ADDENDUM NUMBER 1

NOTIFICATION DATE:	BID TITLE:	BID NUMBER:	BID OPENING DATE & TIME:
04/11/14	WWTP Reuse Pump Replacement	14-037	04/25/14 2:00PM

CITY OF NAPLES
WASTEWATER TREATMENT PLANT
REUSE PUMP UPGRADES

Exhibit B - Revised Sheet E-601 POWER ONE-LINE_R

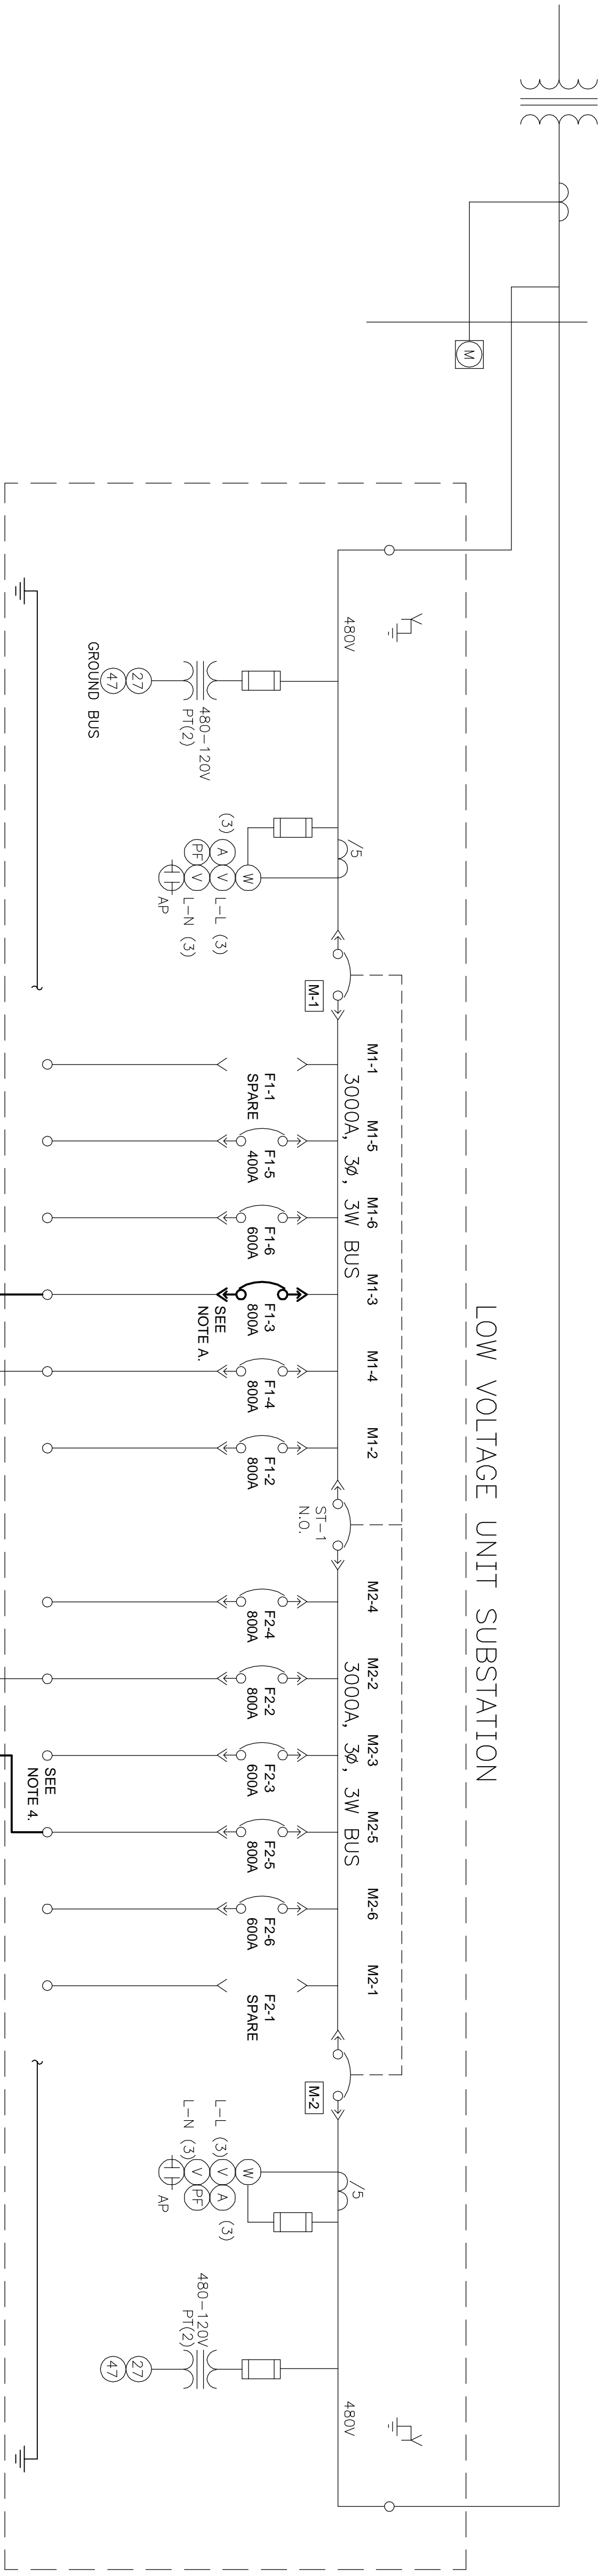
Exhibit B - REVISED E-601 POWER ONE-LINE

- A. SWITCHGEAR BREAKER REPLACEMENT**
 REPLACE EXISTING BREAKER WITH NEW 800A BREAKER FOR PUMP #3 FEEDER. MODIFY SWITCHGEAR AS REQUIRED TO INSTALL NEW BREAKER. OBTAIN THE SERVICES OF GE ENERGY MANAGEMENT OR SCHNEIDER ELECTRIC FOR WORK AND COMPONENTS INVOLVED WITH THE REPLACEMENT OF THE BREAKER. COORDINATE WORK AND EQUIPMENT SHUT DOWNS WITH THE OWNER. BREAKER REPLACEMENT SHALL INCLUDE THE WORK TO PERFORM ONE OF THE FOLLOWING OPTIONS:

1) FOR A NEW BREAKER TO BE INSTALLED WITH BUS AND CABLE CONNECTIONS AND COMPONENTS NECESSARY FOR THE INSTALLATION FABRICATED TO MATCH THE SWITCHGEAR.
 2) FOR AN ADD-ON PANEL WITH ANY BUS MODIFICATION TO BE MADE TO INCORPORATE THE NEW BREAKER SHOWN.

3) FOR A FACTORY CERTIFIED REFURBISHED BREAKER TO BE UTILIZED PROVIDED THAT THE BREAKER MEETS THE ORIGINAL DESIGN AND PERFORMANCE SPECIFICATIONS (VERIFIED THROUGH TESTING) AND PROVIDED THAT THE BREAKER BE PROVIDED WITH A 2 YEAR WARRANTY.

- NOTES:**
 1. REUSE EXISTING CONDUIT BETWEEN SUBSTATION AND VFD LOCATIONS WHERE PRACTICAL, MODIFY AND EXTEND CONDUIT AS REQUIRED FOR NEW INSTALLATION AT THE VFD'S. PULL NEW WIRE WITHIN EXISTING AND NEW CONDUIT.

2. PUMP #4 MOTOR REPLACEMENT WILL BE PERFORMED IN THE FUTURE. NOT INCLUDED IN THIS CONTRACT.
 3. INSTALL NEW CONDUIT AND WIRE AS INDICATED.
 4. REUSE EXISTING SPARE 800A CIRCUIT BREAKER FOR PUMP #4 VFD FEEDER CIRCUIT. REROUTE CABLES WITHIN SWITCHGEAR AS NECESSARY.

5. THE NEW HVAC UNITS, VFD'S, CONDUIT AND WIRE SHALL BE INSTALLED FIRST TO EACH PUMP. WITH ONLY ONE PUMP OUT OF SERVICE AT ANY TIME. VFD'S SHALL BE CONFIGURED FOR THE ACTUAL MOTOR CONNECTED. ONCE THE WIRING AND PROGRAMMING ARE COMPLETED, THE 350HP PUMP REPLACEMENT SHALL TAKE PLACE.

6. VFD'S SHALL BE CONFIGURED FOR THE ACTUAL MOTOR CONNECTED. ONCE THE WIRING AND PROGRAMMING ARE COMPLETED, THE 350HP PUMP REPLACEMENT SHALL TAKE PLACE.

7. TURN OVER ALL THE CONNECTIONS TO MOTORS TO VFD TYPE CABLES.
 8. ALL POWER WIRE FROM VFD TO MOTORS SHALL BE VFD TYPE CABLES.
